SUBJECT: ELECTRONIC TYPEWRITER DIAGNOSTIC TOOL (XTDT)

SUBJECT: YOKE BREAKAGE – RIBBON CASSETTE CARRIER

SUBJECT: NEGATIVE CAM FOLLOWER – REDESIGNED

Figure 1

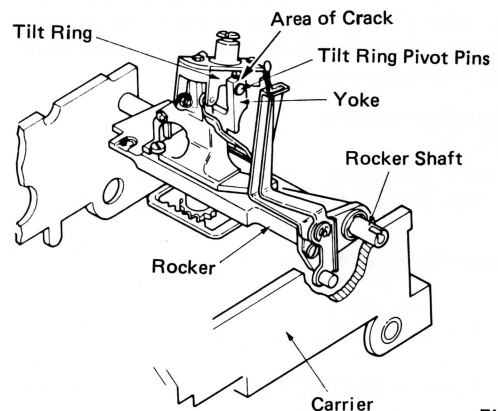
Poor print quality, especially of the underscore, may be caused by a crack in the yoke near the tilt ring pivot pins. (Figure 1)

If the yoke is found to be cracked, replace the rocker asm. (2-450: Part Number 1440310) rather than the carrier asm. A method of removing the rocker is as follows:

1. Remove cardholder bracket asm. (2-493).
2. Disconnect shift mode switch (3-309).
3. Loosen the rocker pivot shaft retaining screws (2-6, 2-404).
4. Remove rocker pivot shaft retaining "C"-clip (2-274).
5. Remove rocker return spring (2-313).
6. Slide rocker pivot shaft to the left until the shaft is out of the rocker asm. (2-272). [Holding the thrust washer (2-271)].
7. Remove the rocker asm. (2-450).
8. Install new rocker asm., reverse steps 1-6.
9. Check all related selection adjustments.

Figure 1

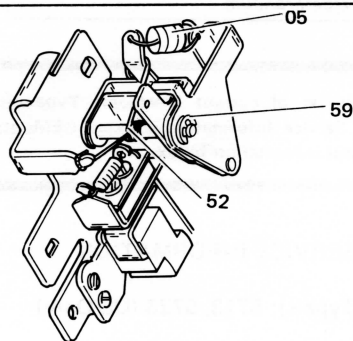
If experiencing piling, chugging (Model 50/60) or system busy (Model 75) install the redesigned knockoff arm return spring (06-52). This spring provides more reliable inhibitor restoring and increases the escapement magnet seal force. The old knockoff arm return spring should be removed and discarded.

To install the spring remove the C-clip (06-59) and slide the components on the stud to the left until the spring can be installed, then reassemble. The override spring (06-05) may be removed to facilitate installation.

Figure 1

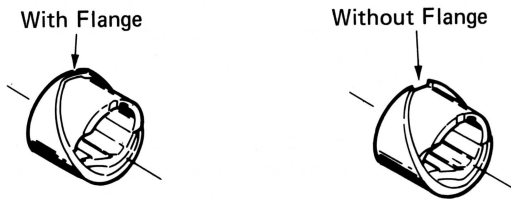
Some Ribbon Cassette System machines contain tape lift and feed cams (02-498) without a flange on the low dwell of the tape lift camming surface (Figure 1). A missing flange does not affect tape lift and will not cause correcting tape lift failures.

Figure 1

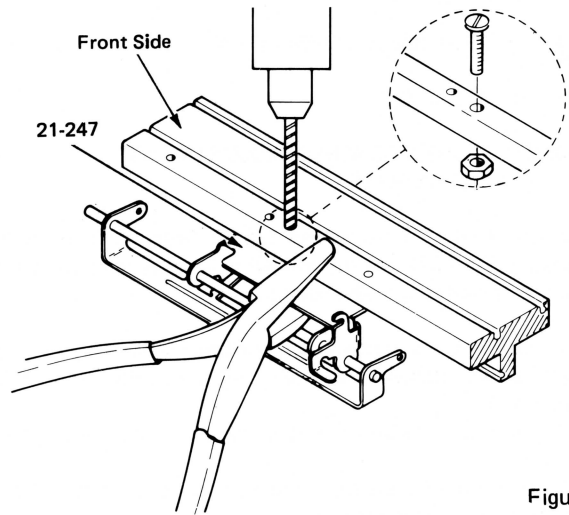
If the keyboard bellcrank mounting bracket screw (21-249) breaks and the remaining part of the screw cannot be removed, use the following procedure. Remove the keyboard assembly (21-264, 265) and drill a hole (Fig. 1) through the frame (08-16) and the bracket (21-247) alongside the existing screw, using a #29 drill bit (P/N 0450163). Install a new screw (P/N 1164581) and a nut (P/N 1134842). The nut should be installed on the rear side of the frame.

NOTE: To facilitate the drilling, the frame and the bracket may be held together with duck bill pliers.

Figure 1

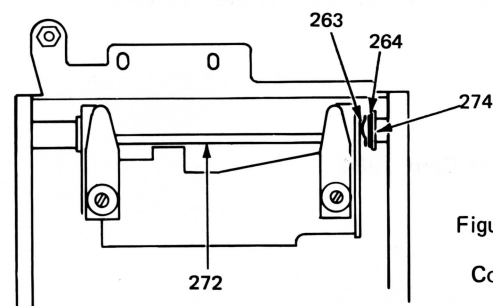
A compression washer (02-263) and a flat washer (02-264) have been added between the rocker and retaining C-clip (02-274) on the rocker pivot shaft. The washers eliminate rocker end play and reduce rocker "bounce" during a repeat underscore. The rocker shaft (02-272) has been modified by increasing the length of the flat area.

When experiencing inconsistent print quality and/or voids in low velocity repeat characters and all print adjustments are correct (particularly velocity cam follower clearance), install the compression washer B/M (02-270). Lubricate the washers before assembly with a film of #23 grease.

Adjust the rocker shaft to compress the washer without causing an excessive bind. To do this, half cycle the print shaft and load the rocker shaft to the left with a minimum of 6 lbs. of force to compress the washer (a spring scale may be used). Then tighten the retaining screws (02-6, 404). While still half cycled check for binds by manually moving the rocker to the print position. The rocker must restore completely under tension of the restoring spring.

Figure 1

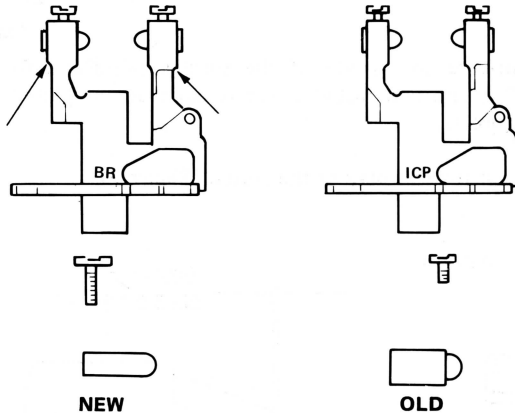
Carrier yokes (02-275/276) have been redesigned to prevent cracking around the tilt ring pin screw (02-269) hole. These yokes will have thicker uprights and use smaller diameter tilt ring pins (02-278) and longer tilt ring pin screws (02-269). See Figure 1.

Figure 1

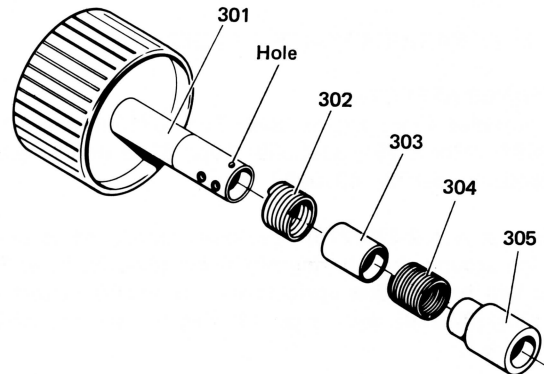
An override clutch has been added to the left end of the platen assembly. The clutch prevents index and alignment failures caused by inconsistent drive in the index mechanism.

1. Remove and discard the left platen knob (22-301), left bushing (22-305), and the washer between the index emitter wheel (23-20) and the c-clip (23-21).
2. Insert the extension of the override spring (22-302) into the hole in the new platen knob shaft (Figure 1).

Figure 2

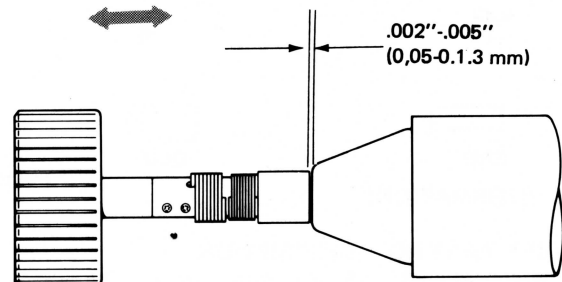
3. Lubricate the inside of the springs (22-302/304) with #23 grease and install the new parts on the platen shaft (Figure 1).
4. Adjust the end play of the clutch (Figure 2).

Figure 1

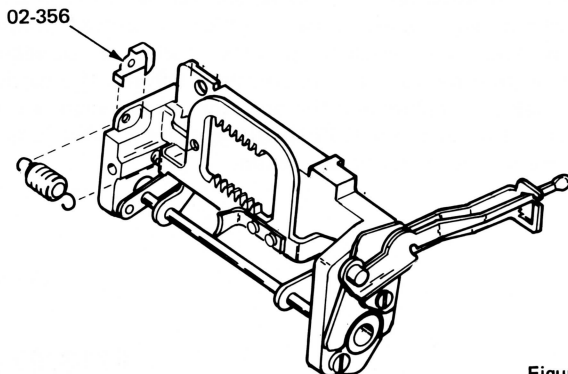
A wear prevention clip is now available to prevent the rack return spring (02-298) from wearing through the rocker casting (02-289). The clip also provides a new surface if the rocker casting is partially worn or completely worn through. The existing spring will be used with the clip.

Note: Squeezing the clip together slightly before installing will help hold it in place while remounting the spring (Fig. 1).

Figure 1

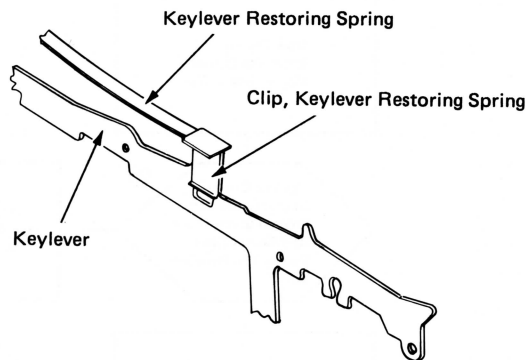
A single operation keylever restoring spring clip (21-85) and a repeat operation keylever restoring spring clip (21-86) are now available for use on Electronic Typewriters Model 50/60/75. These clips will prevent the keylever restoring spring (21-74, 80) from slipping off the keylever.

When installing either clip remove top section of the keyboard (21-084). To install a single-operation keylever restoring spring clip, slide the flat part of the clip on the restoring spring first (Fig. 1).

Figure 1

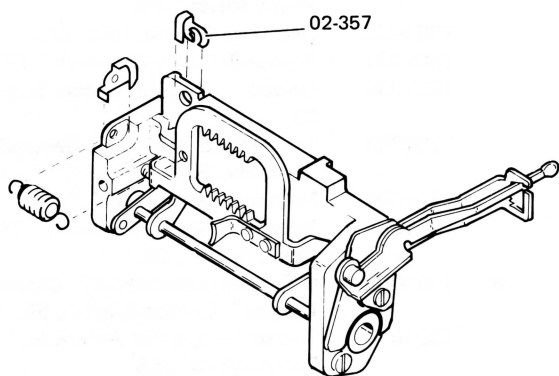
A wear prevention clip is now available to prevent the rocker return spring (02-313) from wearing through the rocker casting (02-289). The clip also provides a new surface if the rocker casting is partially worn or completely worn through. The existing spring will be used with the clip.

Figure 1

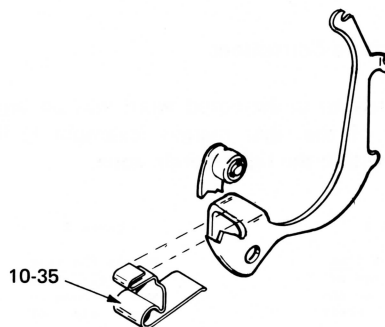
A cycle clutch latch support has been released for field use. This support will reduce PSCC extra cycles caused by the latch not holding the sleeve.

To install the support, remove the print shaft belt, the PSCC backcheck pawl (10-44) and the restore arm (10-71). Slide the support onto the restore arm (fig. 1) and re-install the restore arm (fig. 2), the backcheck pawl, and the print shaft belt.

Figure 1

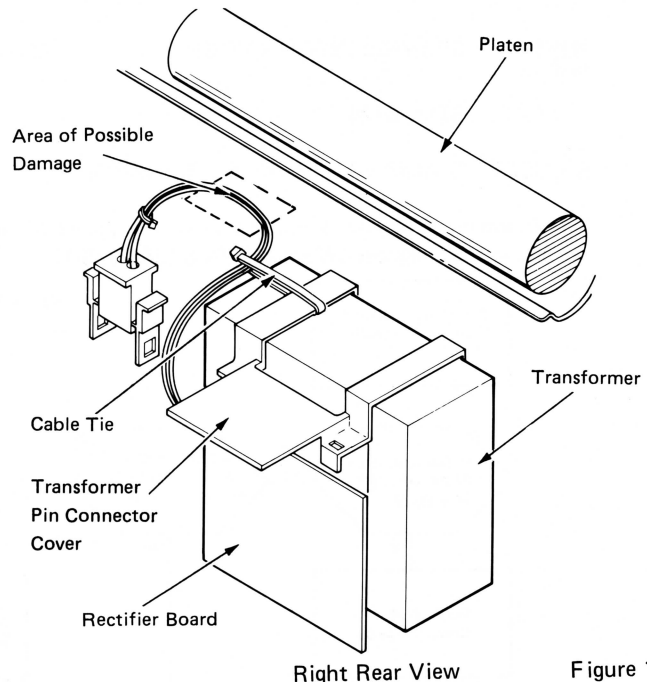
Affected machines must be inspected **at the earliest opportunity** for the existence of this condition. Observe proper safety precautions! Prior to inspecting the machine, position the carrier approximately 1 inch from the RH side frame to minimize the possibility of contact between the leadscrew nut and transformer leads. If the customer reports any of the above symptoms, remove the line cord from the wall outlet before removing the machine cover or inspecting for lead damage.

Install wire tie (29-03) between the transformer leads and the transformer pin connector cover (12-52) (see Figure 1) on **all** machines within the specified serial range to ensure adequate clearance between the transformer leads and the leadscrew nut. The cable tie is plantinstalled above the specified serial range.

Figure 1

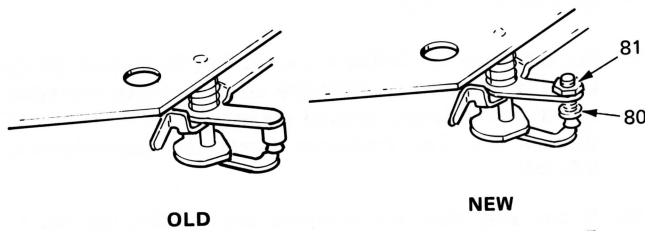
The tape lift cam follower has been redesigned to provide a more consistent method of adjusting its height. The follower is now threaded through the follower bellcrank and is adjusted with a bristol wrench. A nut secures the adjustment.

- With the correcting control arm (02-501) on the high point of the correcting restore cam (02-499), adjust the correcting control arm eccentric (02-503), for .012" to .020" clearance between the latch surface of the correcting control arm and the erase latch. Keep the eccentric toward the rear.

BELL CHART

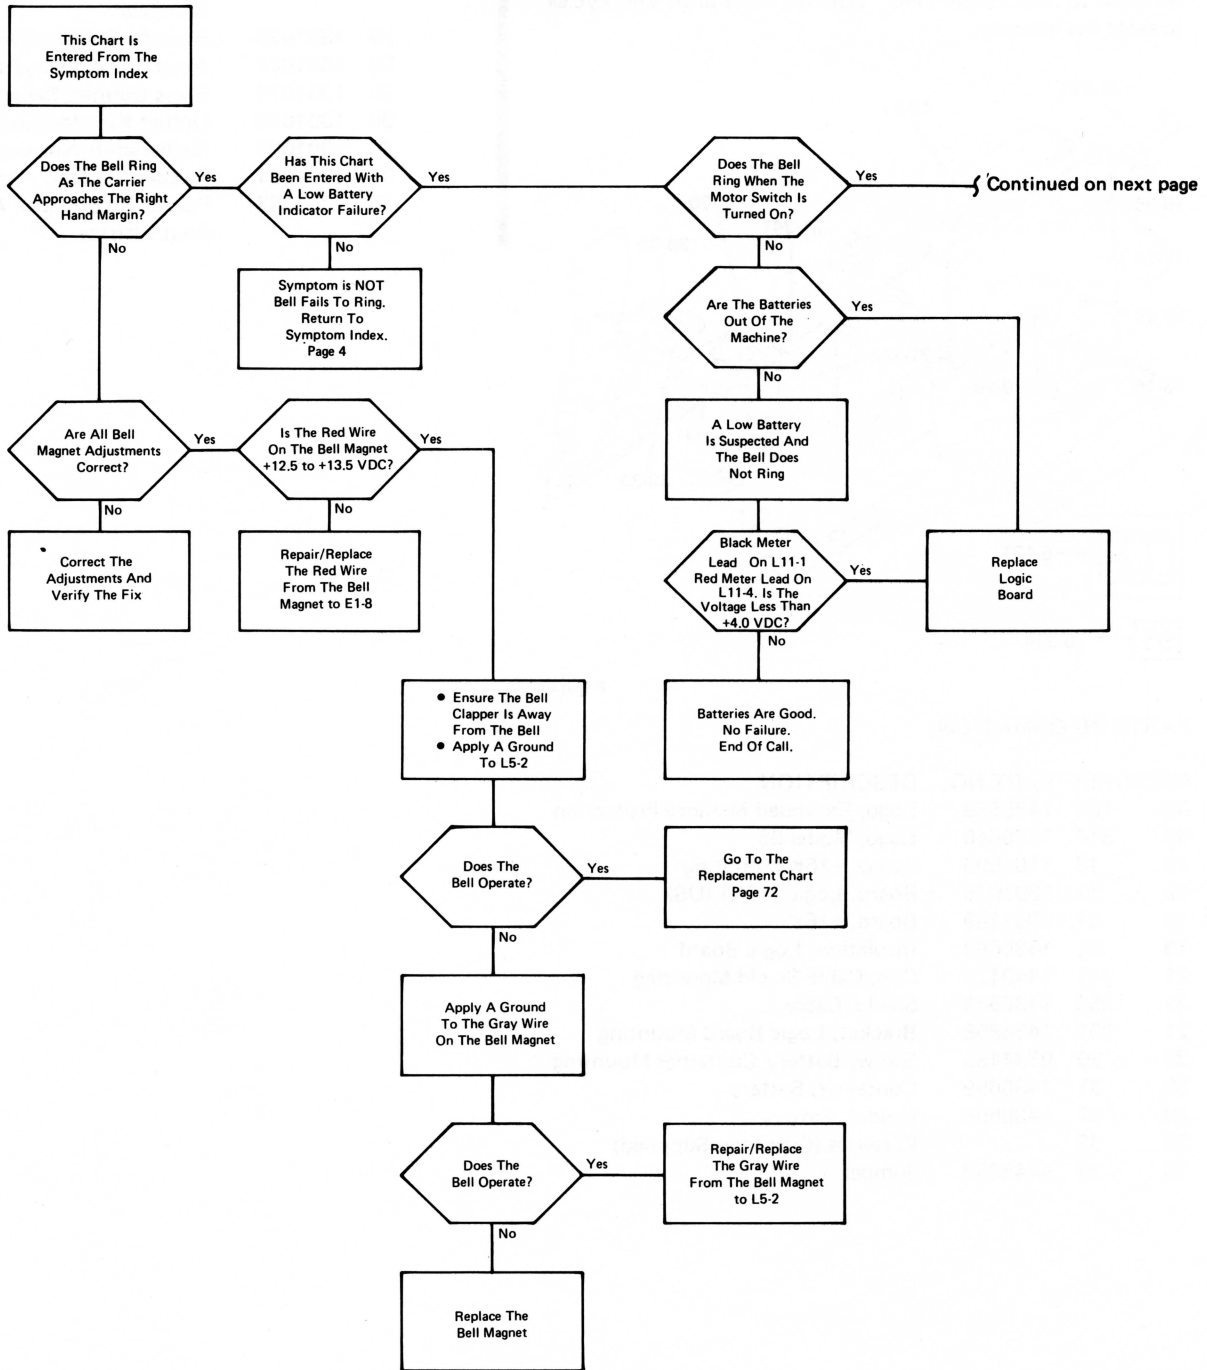
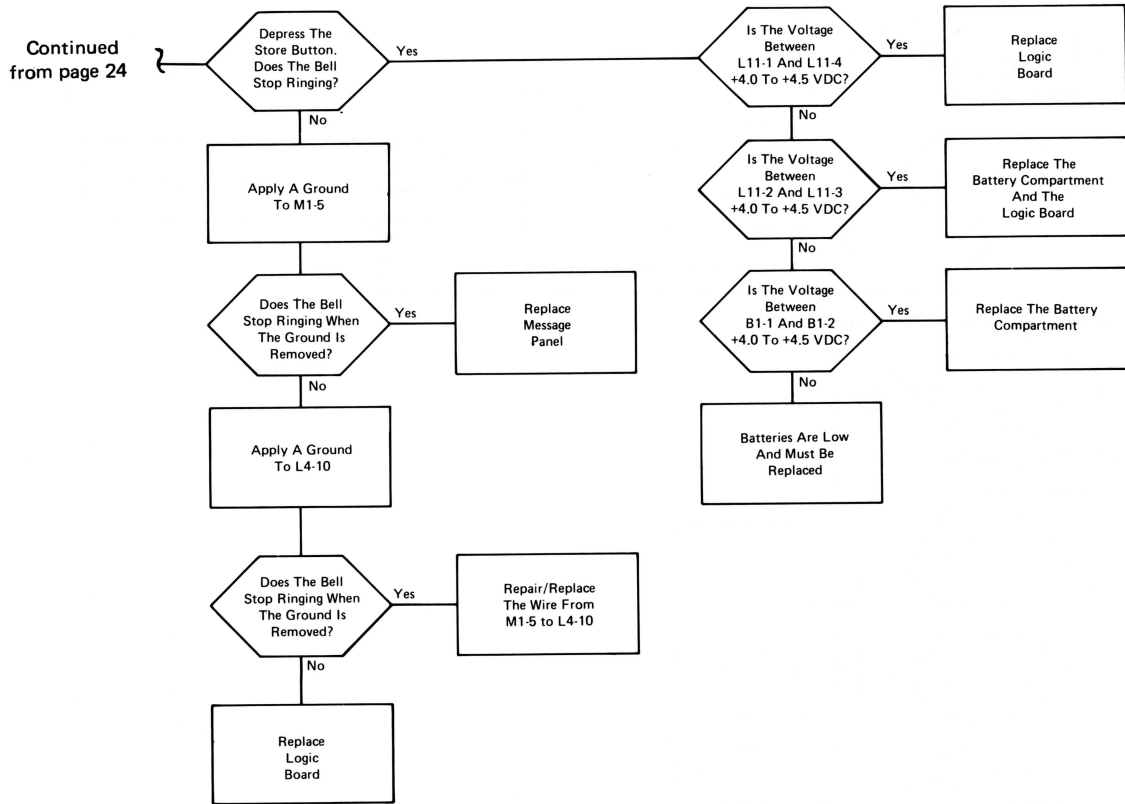
Three diagnostic charts have been changed to reflect a machine with Extended Memory Protection installed. These are the Bell Chart (Figure 2), the Replacement Chart 1 (Figure 3), and the Replacement Chart 2 (Figure 4).

Figure 1

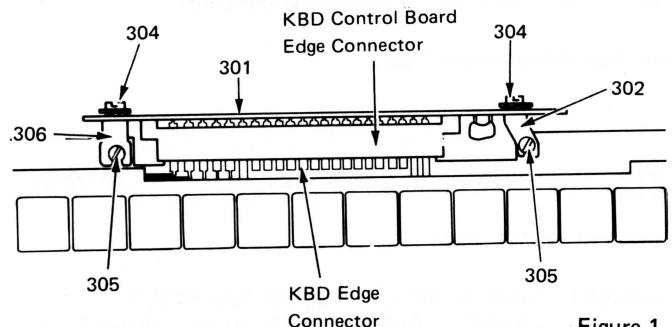
When a malfunctioning row or column of keybuttons is encountered, the problem may be caused by poor connection between the keyboard control board (21-301) and the keyboard (21-303). The following procedure can be used to correct this problem: Loosen keyboard logic clip mounting screws (21-305), disconnect keyboard control board (21-301) from keyboard and clean the keyboard edge connector (visible oxidation may be cleaned with an eraser). Loosen both keyboard logic mounting screws (21-304). When reinstalling the parts, tighten keyboard logic clip mounting screws (21-305), before tightening the keyboard logic mounting screws (21-304). This procedure will help eliminate any stressful condition between keyboard edge connector, keyboard logic mounting clips (21-302, 306) and keyboard control board. (Figure 1)

NOTE: Some early level keyboard logic mounting clips (21-302, 306) were shorter and affected the edge connector's reliability by forcing the top of the connector upwards, opening its contacts. If, when reconnecting, the keyboard control board edge connector and the keyboard edge connector cannot be aligned without downward pressure to the connector, replace the keyboard logic mounting clips.

Figure 1

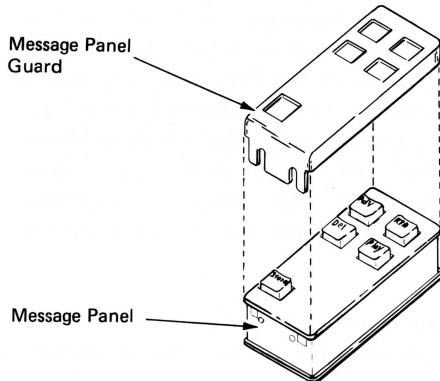
A message control panel guard (20-75) is now available for installation on Models 65, 75, 85 and 95. The new guard, when installed, will prevent accidental depression of the message panel buttons. The guard can also be used to eliminate unwanted message panel operations when diagnosing system busy problems.

Figure 1

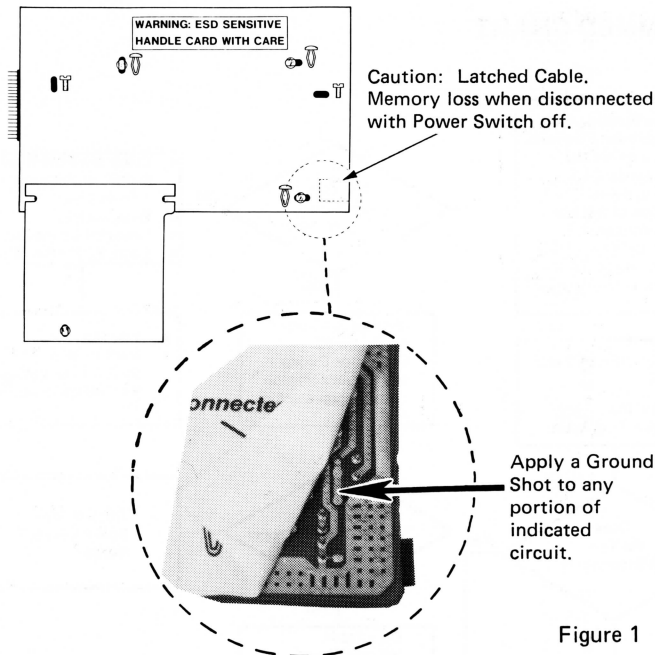
Apply a ground to the CMOS logic board as illustrated in Figure 1 prior to installation of either modularity option or +16K. Use the appropriate MES installation instructions for the remainder of the installation.

1. Main power off.
2. Remove the battery pak.
3. Connect one end of the meter probe to either frame ground or power supply ground.
4. Apply a ground as illustrated in Figure 1.
5. Install the link interface board or +16K board as needed.
6. Re-install the batteries.
7. Main power on.
8. Verify the machine operation.

Figure 1

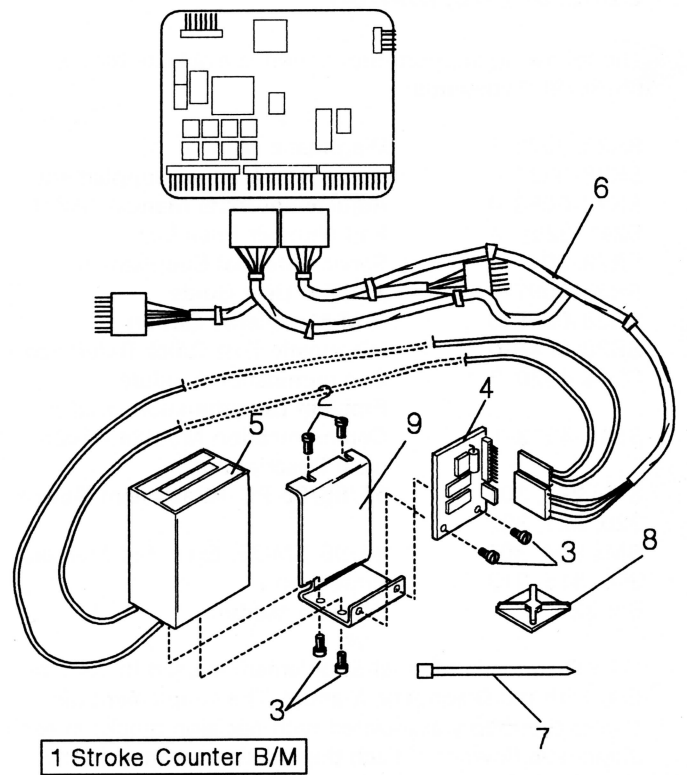
The Stroke Counter B/M for Models 50/60/75, previously ordered by SER, is now available for field ordering through the Greencastle parts system (Figure 1).
